RIDGE NEST - LOT 4

MAKE CORRECTIONS
Weber Fire District
10/09/2014 9:02:45 AM

PROJECT # 1405
DATE: 09/19/14
TITLE:
COVER SHEET
SHEET:
AG-001

10 DECK DETAIL
1 1/2" = 1'-0"

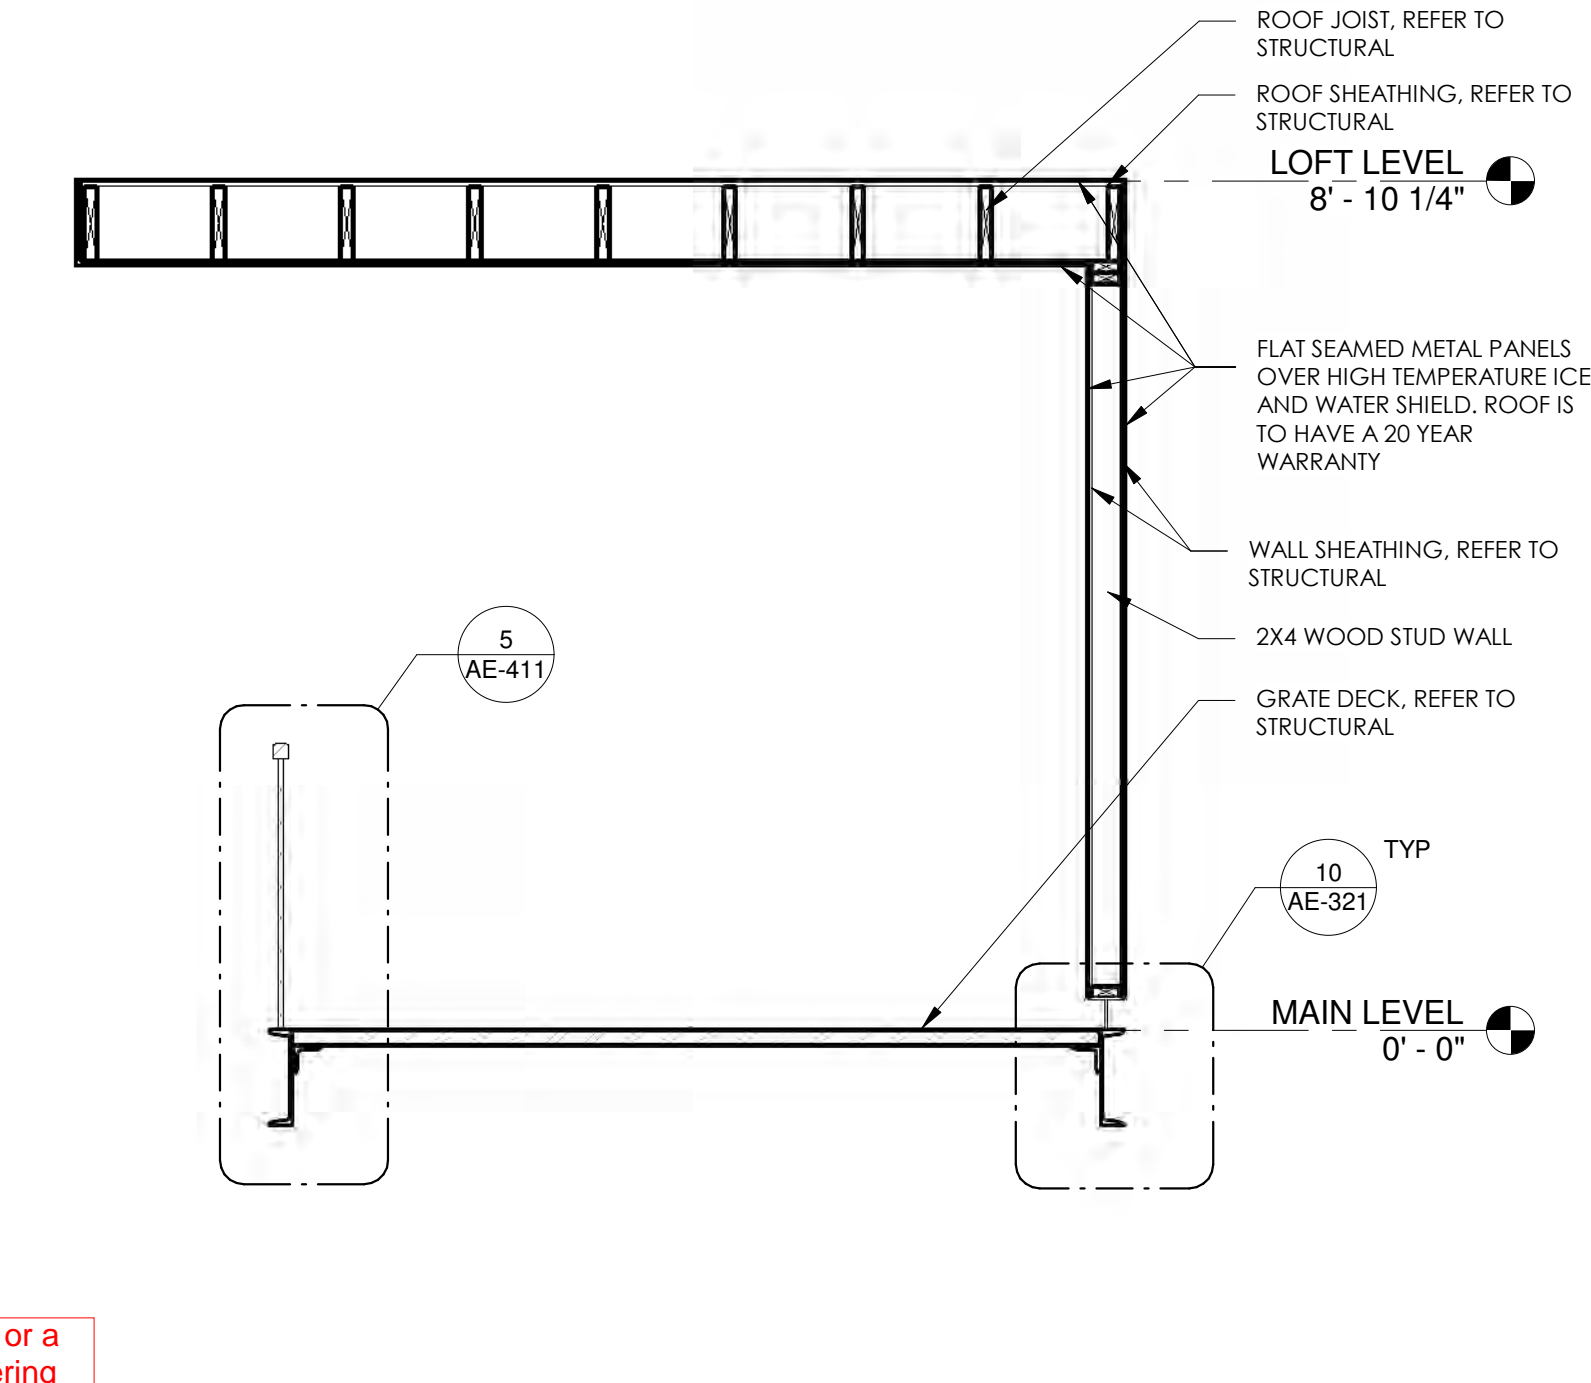
Is this 1/2" GWB or a metal sheet covering the bottom of the structure?
